**TOWN OF NEWBURGH
PLANNING BOARD
TECHNICAL REVIEW COMMENTS**

PROJECT: MALMARK
PROJECT NO.: 20-15
PROJECT LOCATION: SECTION 9, BLOCK 3, LOT 2
REVIEW DATE: 28 MAY 2021
MEETING DATE: 3 JUNE 2021
PROJECT REPRESENTATIVE: MECURIO-NORTON- TAROLLI-MARSHALL

Re: Job No. 3807-3
Tax Map Parcel: 9-3-2
Town of Newburgh
Orange County
Lattintown Road
5-lot Residential Subdivision

Survey Map & Subdivision Plan
for
Malmark Construction Corp.

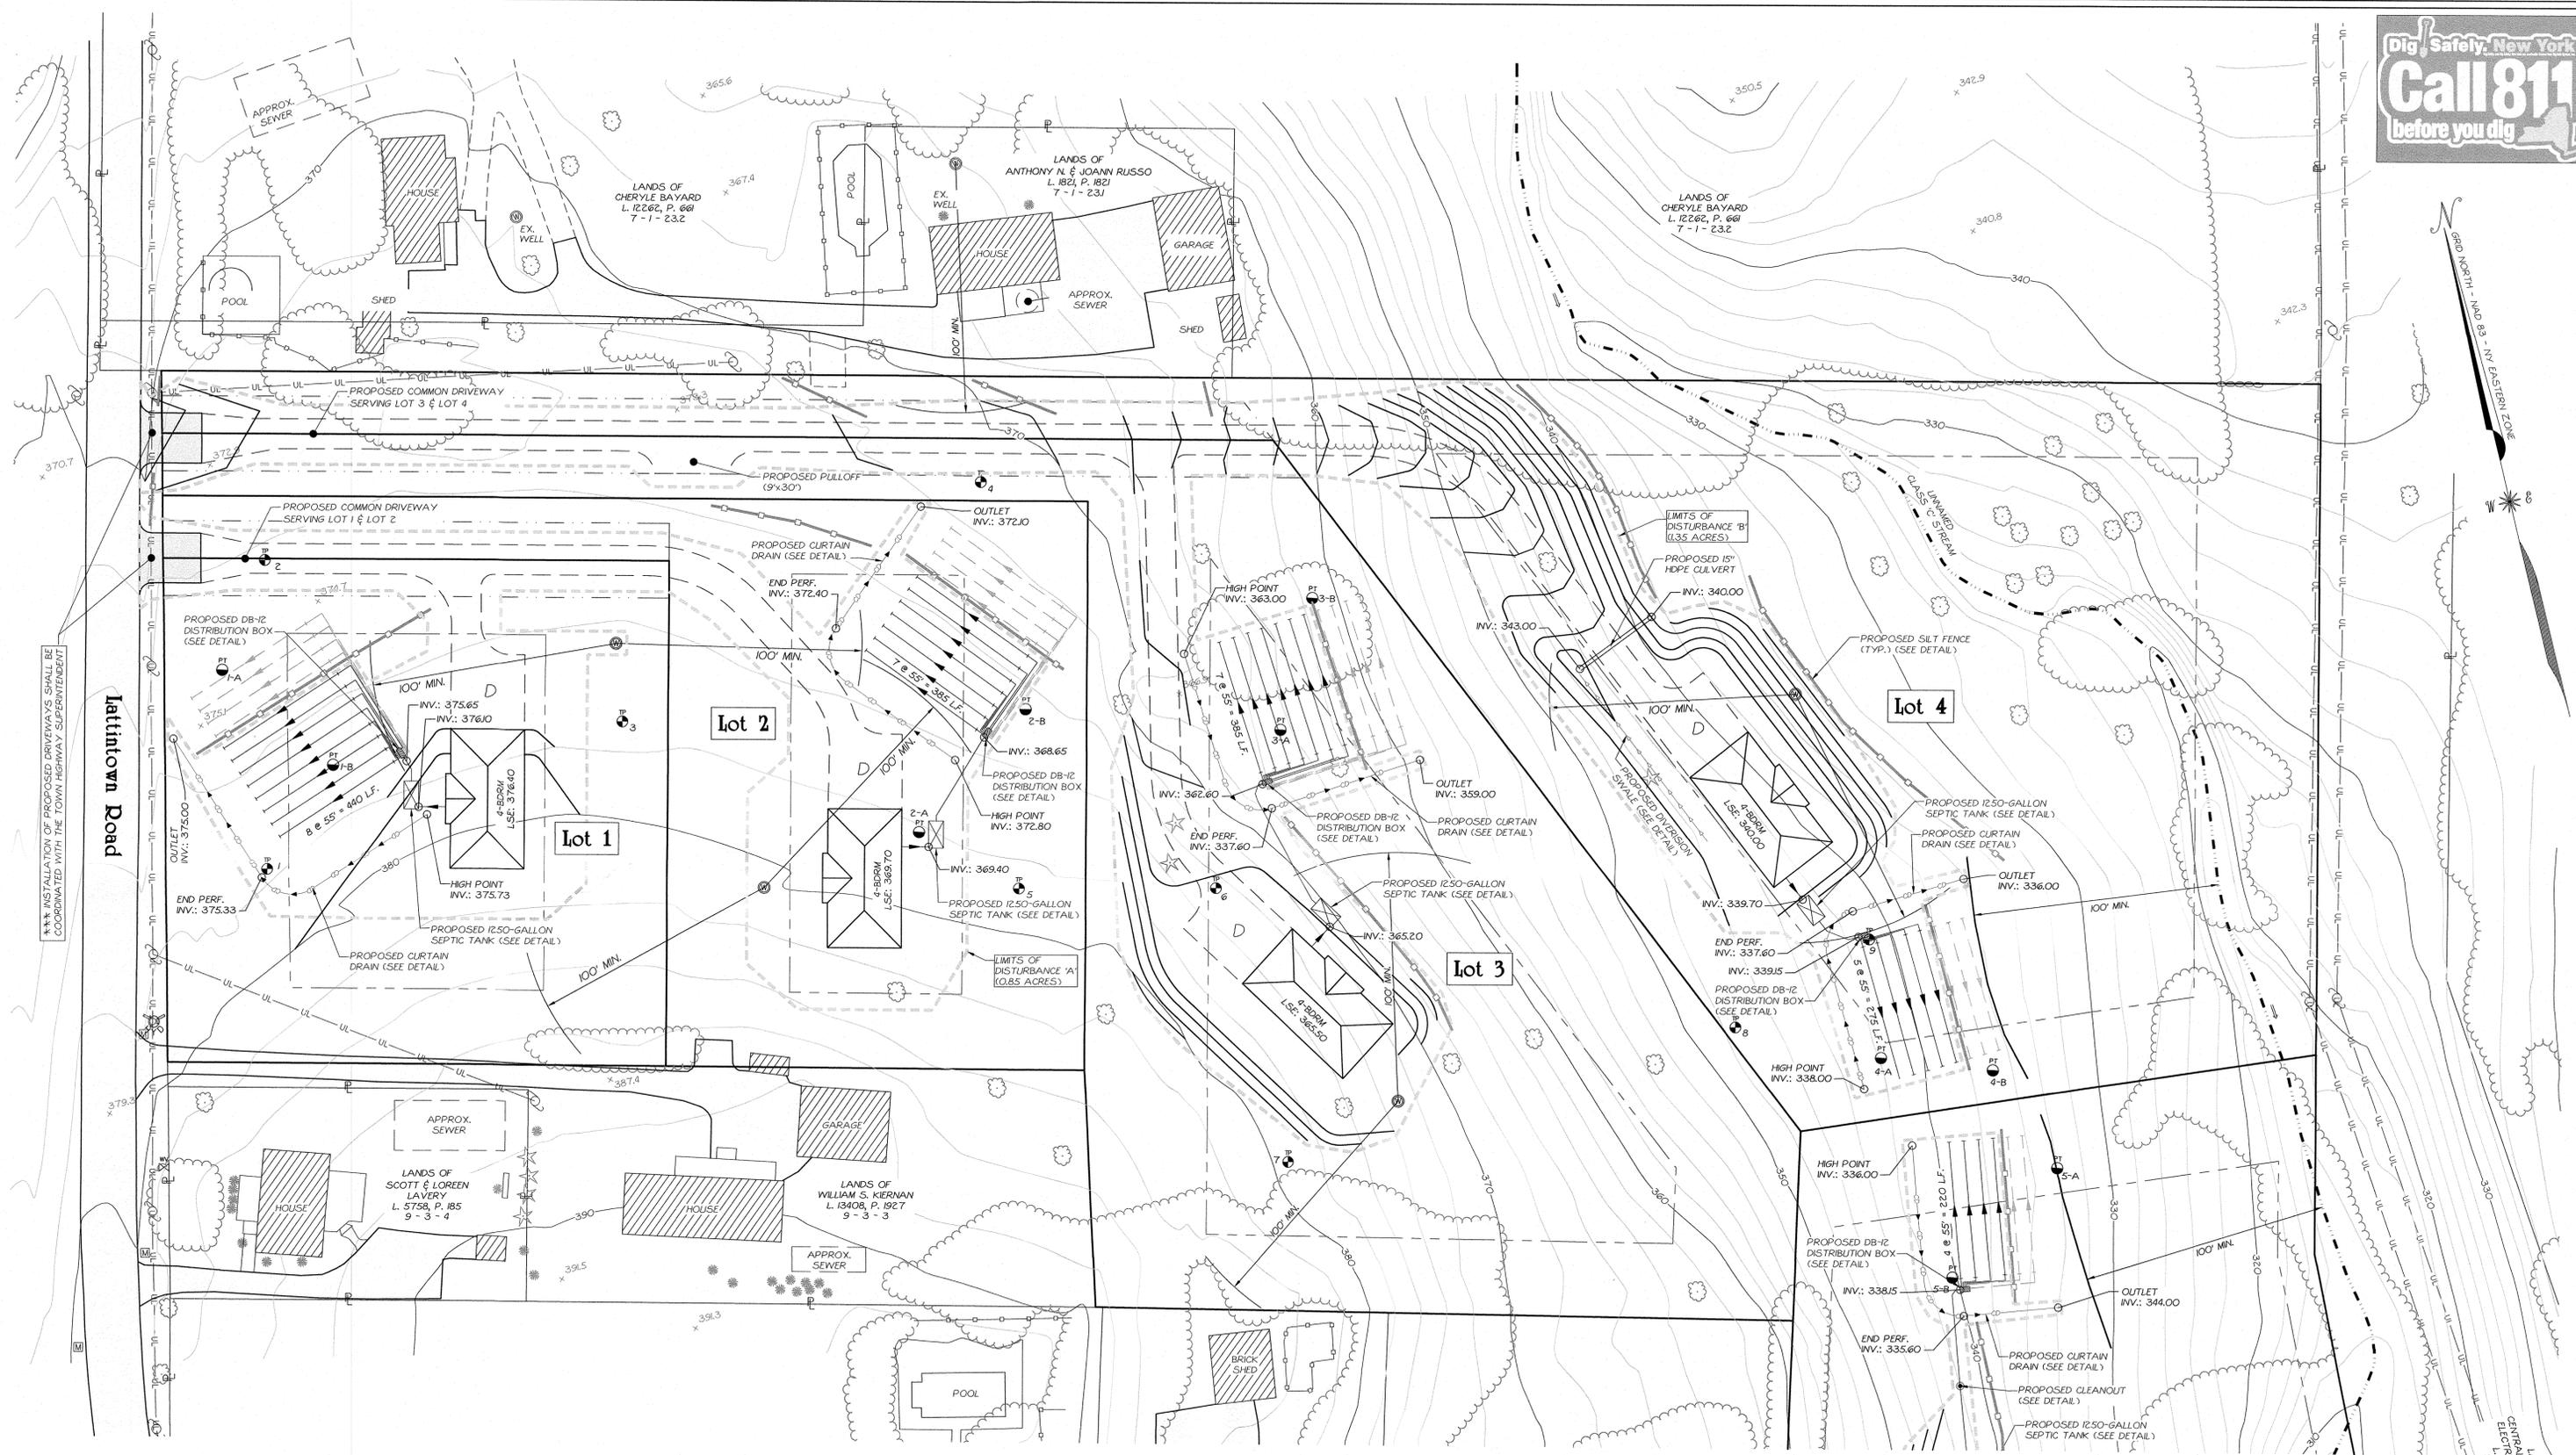
The following comments are in response to a review by Patrick Hines of McGoe, Hauser, & Edsall Consulting Engineers, P.C. dated January 29, 2021:

3. Metes & bounds will be included on the proposed property lines for future submissions.
4. No response required.
5. Reference to the proposed access easements for the common driveways is included in notes 8 and 9 on sheet 1. The easements will include provisions for installation and maintenance of the proposed driveways and utilities serving the individual lots.

9. No response required.
10. Note 1 has been added under the Zoning Legend on sheet 1 specifying lot specific bulk zoning information is provided on sheet 3. Note 10 has also been added on sheet 1 to this effect.

Diversion Swale Detail

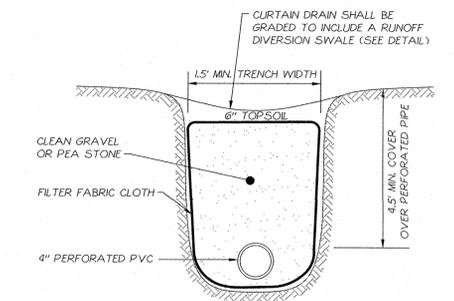
3. In response to written comments received from a neighbor the Applicants representative is requested to evaluate the installation of a swale along the northern portion of the driveway on Lot #4 conveying any surface water to the existing water course on Lot #4.
